**TOWNSHIP OF HARRISON
GLOUCESTER COUNTY, NEW JERSEY**

**WASTEWATER FACILITY
OFFICE CONSTRUCTION**

NOTICE OF ADDENDUM NUMBER 1

ADDENDUM DATE: October 1, 2026

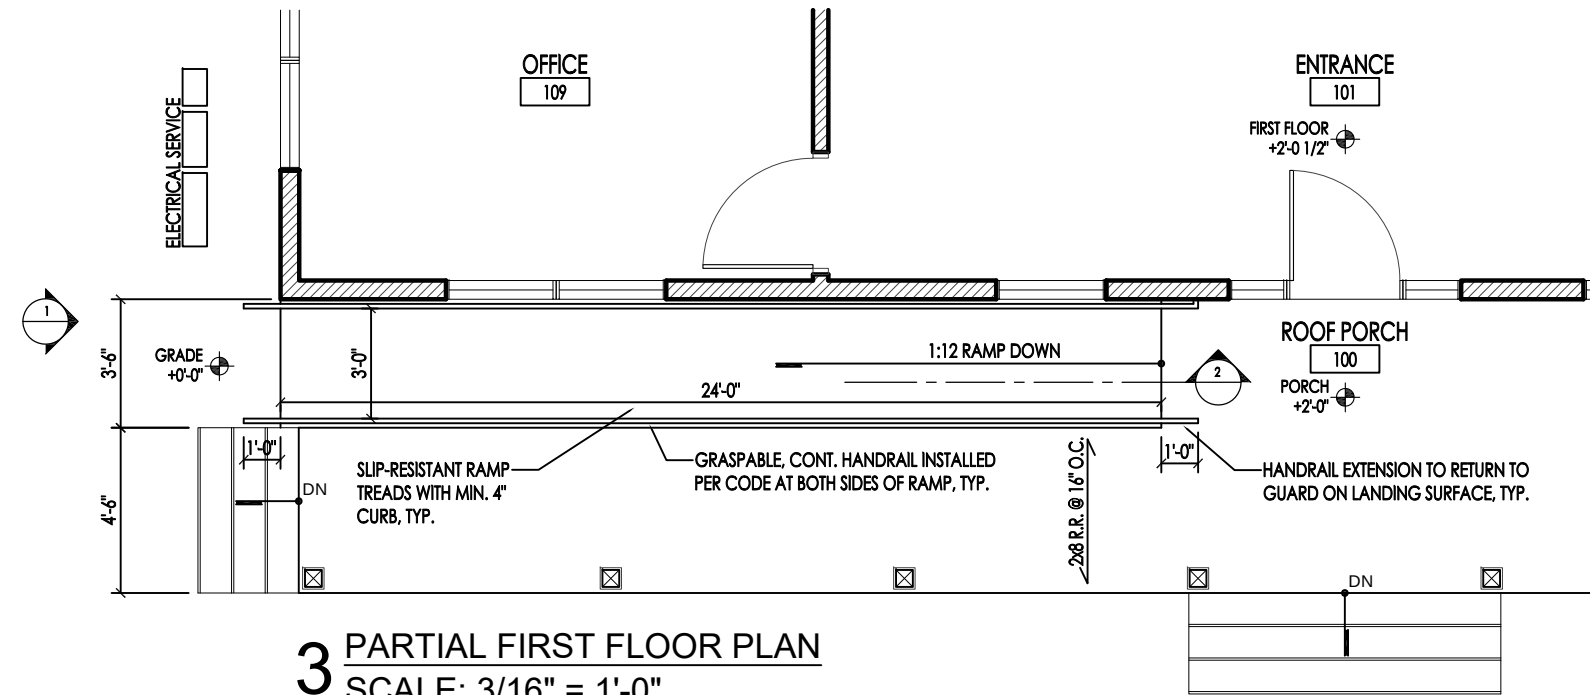
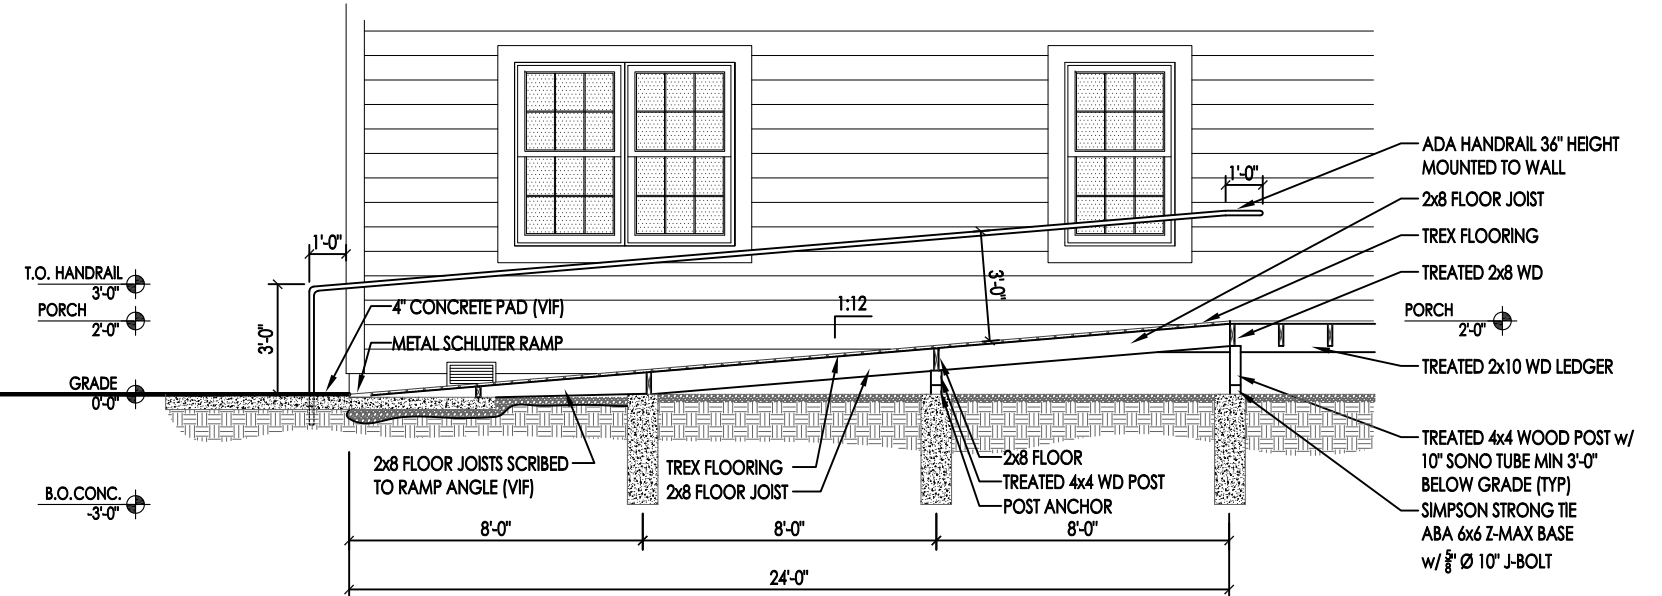
Ramp Detail

An supplemental ramp detail is supplied and attached to this addendum.
